# Errata Sheet

March 30, 2005 / Release 1.1

<b>Device:</b>	<b>SAK-C167CR-L(33)M, SAF-C167CR-L(33)M, SAB-C167CR-L(33)M  SAK-C167CR-4R(33)M, SAF-C167CR-4R(33)M, SAB-C167CR-4R(33)M  SAK-C167CR-16R(33)M, SAF-C167CR-16R(33)M, SAB-C167CR-16R(33)M  SAK-C167SR-L(33)M, SAB-C167SR-L(33)M  SAK-C167CR-LE</b>
<b>Stepping Code / Marking:</b>	<b>ES-HA, HA, HA+</b>
<b>Package:</b>	<b>P-MQFP-144-8 (..C167..-M), P-BGA-176-2 (..C167..-E)</b>

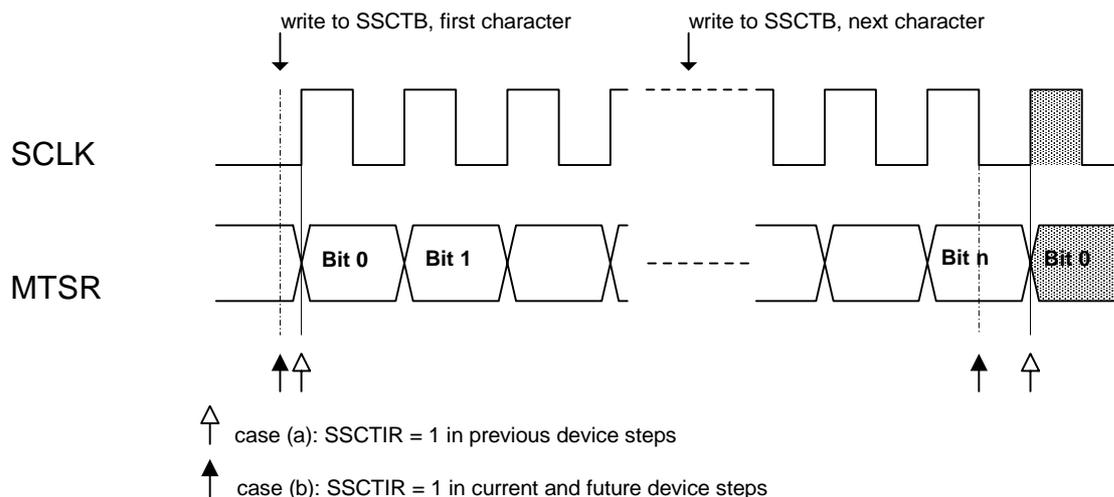
- before step **FA**, flag SSCTIR is set to '1' synchronous to the shift clock SCLK 1/2 bit time before the first latching edge (= first shifting clock edge when SSCPH = 0). When SSCTB is written while the shift register is empty, the maximum delay between the time SSCTB has been written and flag SSCTIR=1 is up to 1/2 bit time.
- beginning with step **FA**, when SSCTB has been written while the transmit shift register was empty (and the SSC is enabled), flag SSCTIR is set to '1' directly after completion of the write operation, independent of the selected baud rate. When the transmit shift register is not empty when SSCTB was written, SSCTIR is set to '1' after the last latching edge of SCLK (= 1/2 bit time before the first shifting edge of the next character). See also e.g. C167CR User's Manual V3.1, p. 12-5.

The following diagram shows these relations in an example for a data transfer in master mode with SSCPO = 0 and SSCPH = 0. It is assumed that the transmit shift register is empty at the time the first character is written to SSCTB:

Typically, in interrupt driven systems, no problems are expected from the modified timing of flag SSCTIR. However, when flag SSCTIR is polled by software in combination with other flags which are set/cleared at the end or at the beginning of a transfer (e.g. SSCBSY), the modified timing may have an effect.
